ADDENDUM No. EIGHT (8)

IFB No. 2021-239

CONSTRUCTION, COLLIN COUNTY ADULT DETENTION FACILITY, PHASE 1 ADDITION

**ADDENDUM NO. 7**

**1 LOWER LEVEL EAST FLOOR PLAN - POWER**  
1/8" = 1'-0"

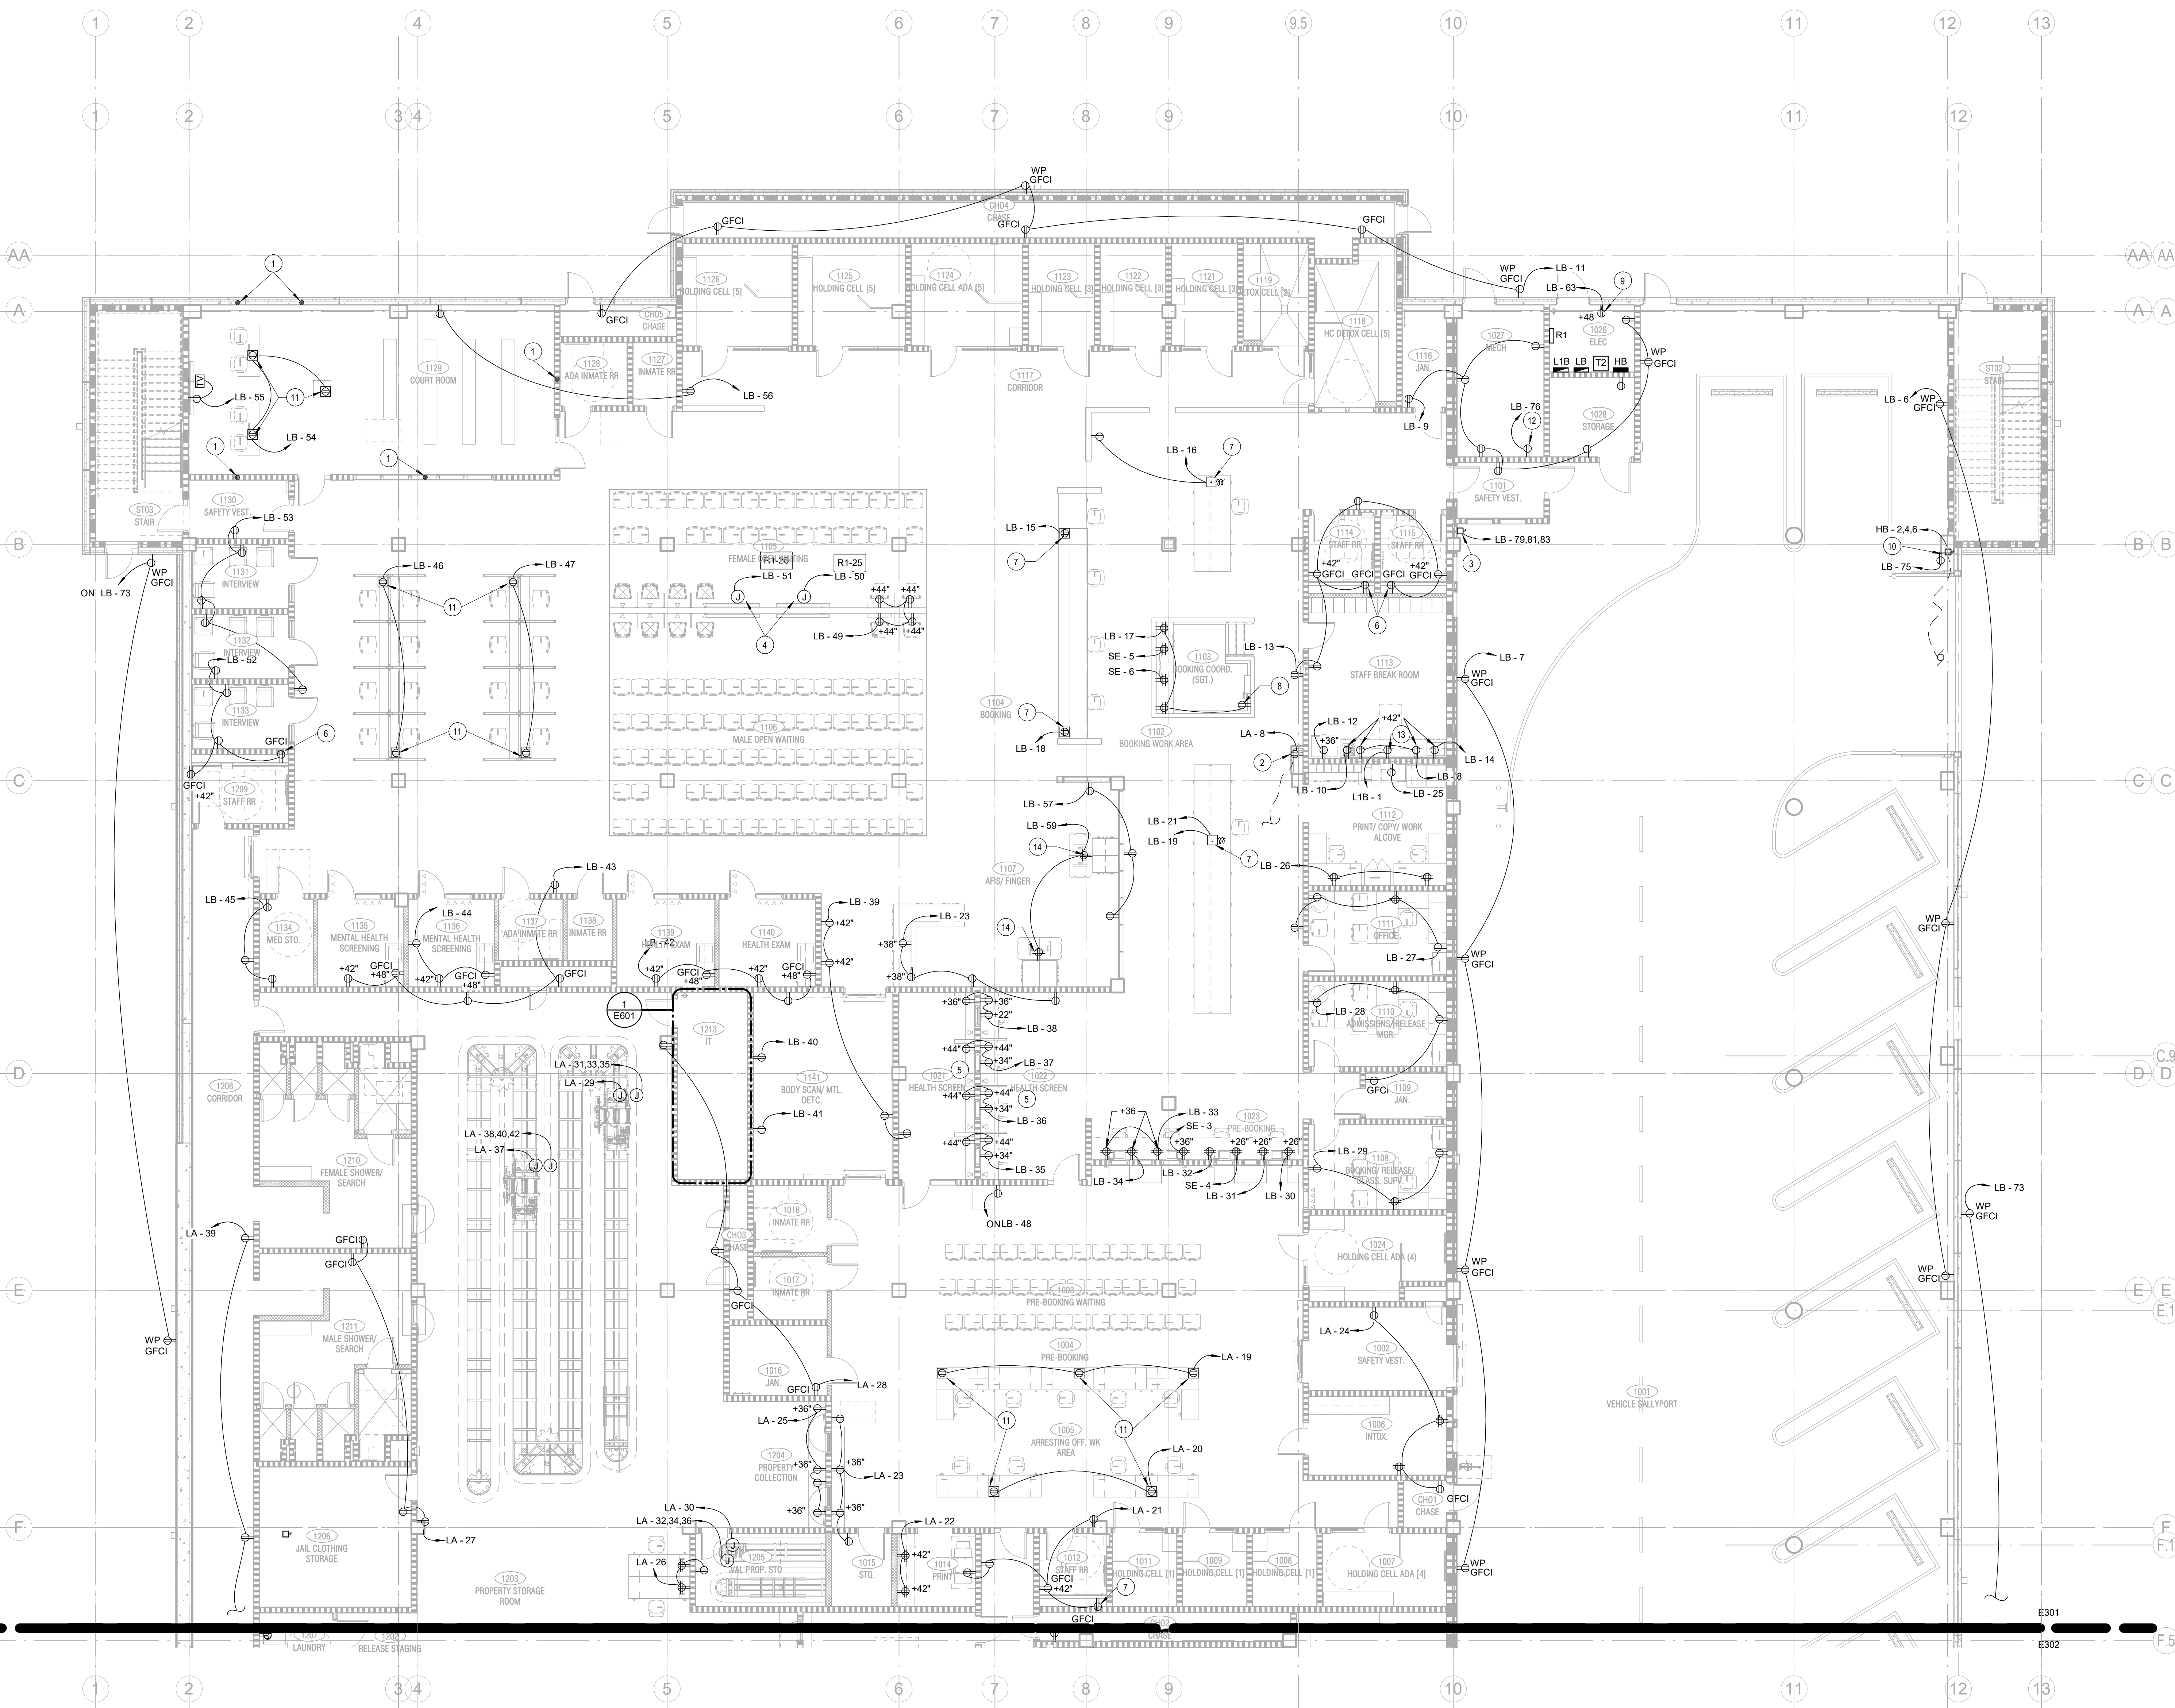
**Item No. 1. Sheet – E301**

A. Revised NBS #10 to read “2 HP” motor.

**1** LOWER LEVEL WEST FLOOR PLAN - POWER  
1/8" = 1'-0"

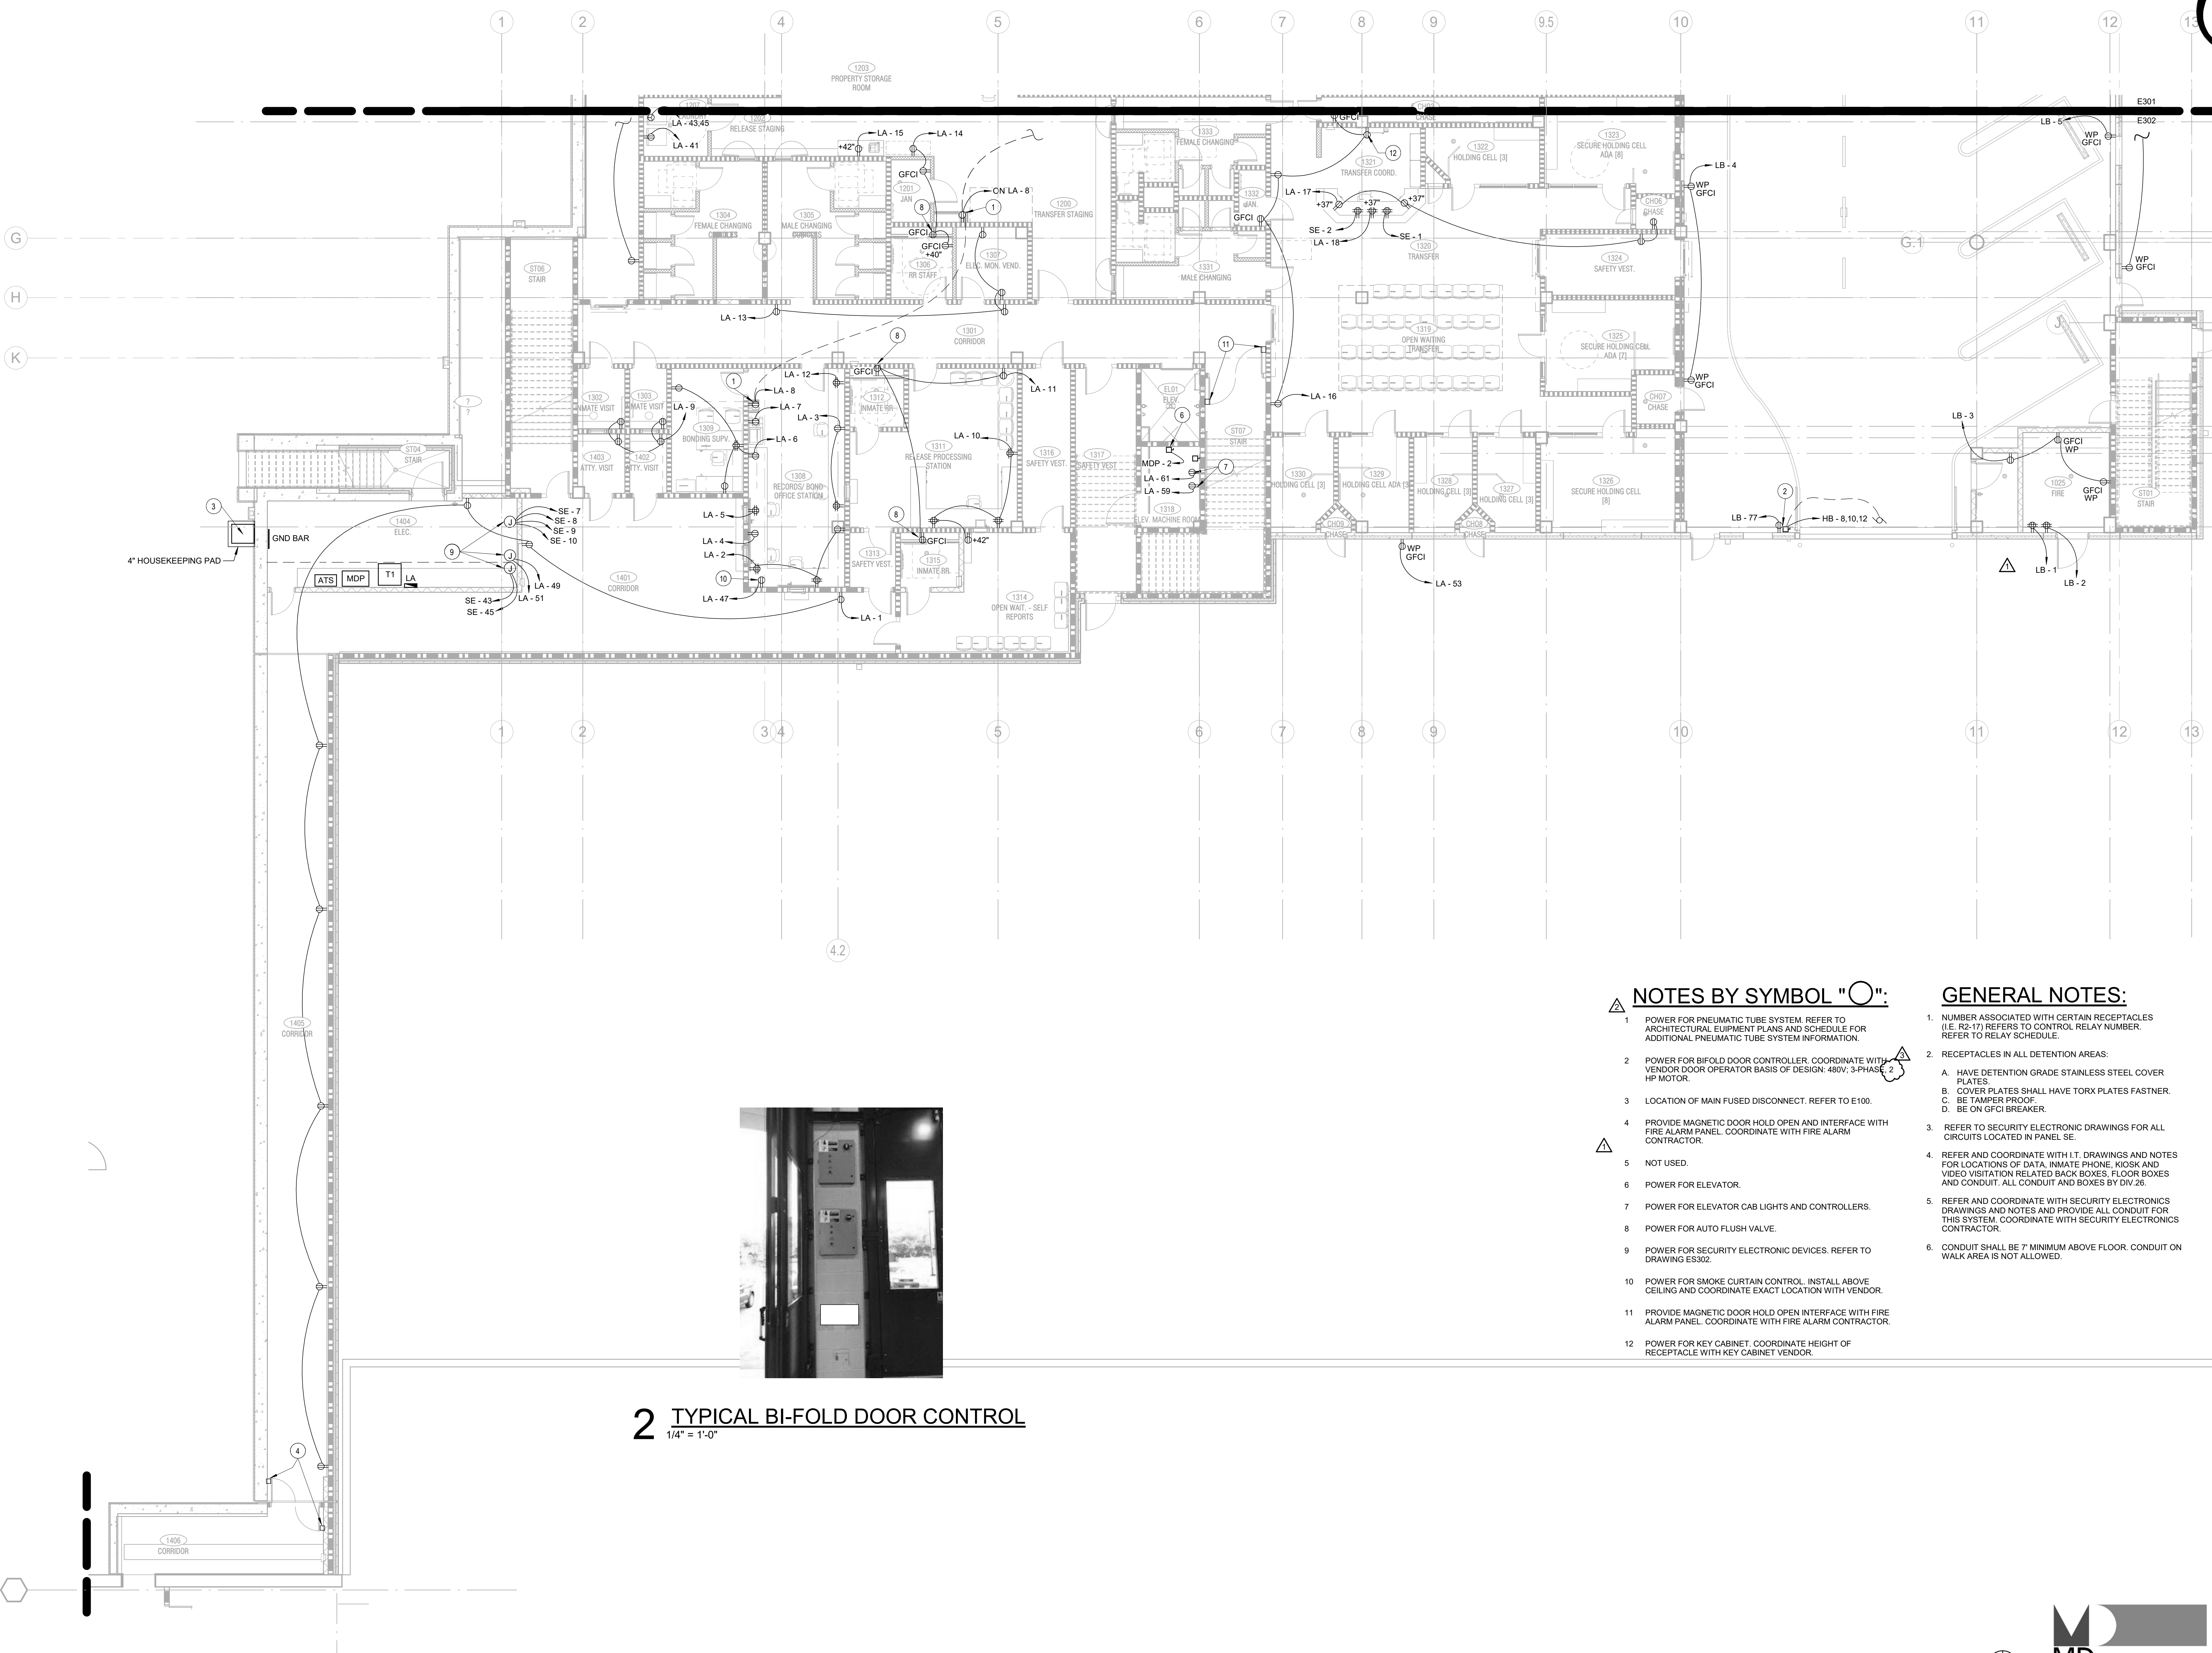
**Item No. 2. Sheet – E302**

A. Revised NBS #2 to read “2 HP” motor.

- POWER FOR BIFOLD DOOR CONTROLLER. COORDINATE WITH VENDOR DOOR OPERATOR BASIS OF DESIGN: 480V, 3-PHASE, 2 HP MOTOR.
  - LOCATION OF MAIN FUSED DISCONNECT. REFER TO E100.
